DEVELOPMENT FACILITATIVE TEAM (DFT)

SP-2025-00047 – SITE PLAN DFT

REQUEST: Site Plan Administrative DFT to increase the square footage of a previously approved development from 44,089 square feet per a Minor-Administrative Amendment and from 49,035 square feet per the original Site Plan – DRB approval to 54,616 square feet (a major amendment)

Project Name: 10000 Central Ave SW

4-3(F)(5) Drive-through or Drive-up Facility

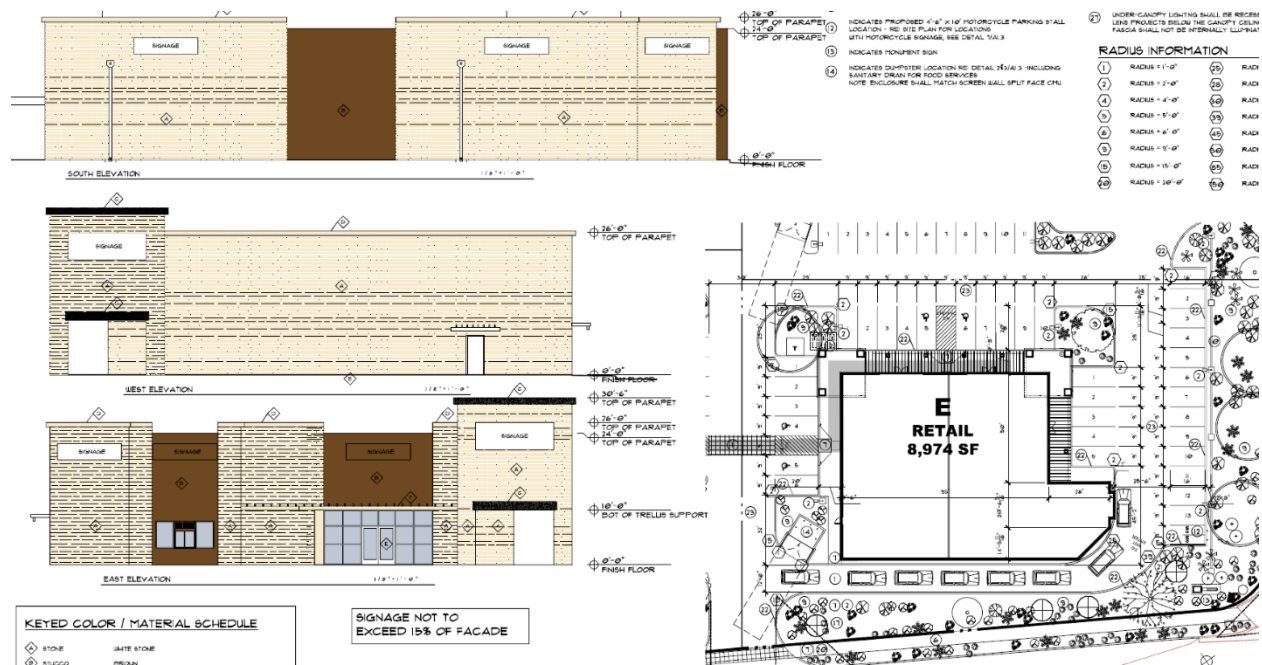
- 4-3(F)(5)(a) Each stacking lane is limited **to a maximum order board area of 50 square feet**. The face of the **order boards shall be oriented away from public streets to the maximum extent practicable**. If not practicable, **at least 2 evergreen trees shall be planted in the landscape buffer area required by Subsection 14-16-5-5(I)(2)(a) in locations that would best screen the order board from the public right-of-way**.
- 4-3(F)(5)(b) This use shall comply with the provisions of Section 14-16-5-5 (Parking and Loading) and Section 14-16-5-9 (Neighborhood Edges).
- 4-3(F)(5)(c) This use is prohibited accessory to cannabis retail.

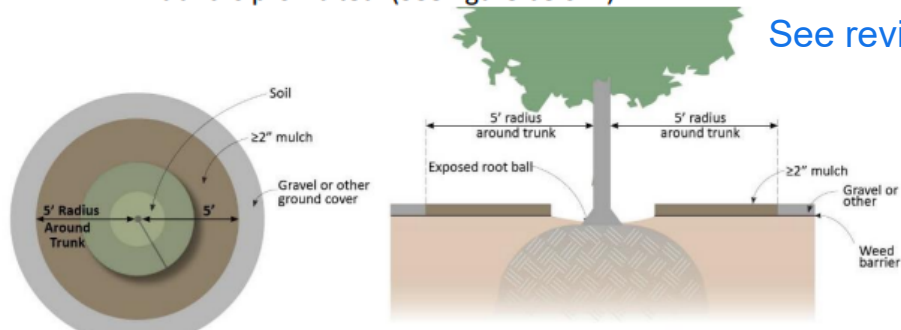
- Please replace the note below from Sheet No. L1.2 with the information from 5-6(C)(5)(e) as it is in conflict with the IDO.

See revised Sheet L1.2

5-11(E)(2) Façade Design

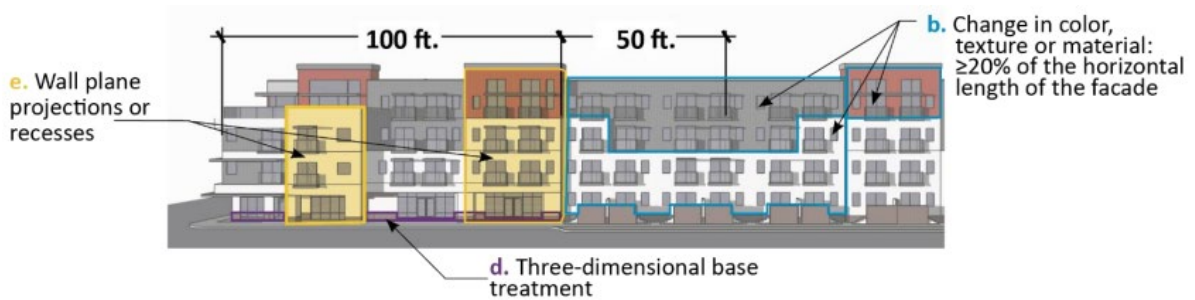
- Please identify which façade elements are being used. This will help during the permitting process if it is directly labeled. Similar to what was done previously in the original Site Plan shown below in Red.

Elevations have been adjusted to show street-facing elements. They are listed on the elevation sheets as well as the revised Justification letter.
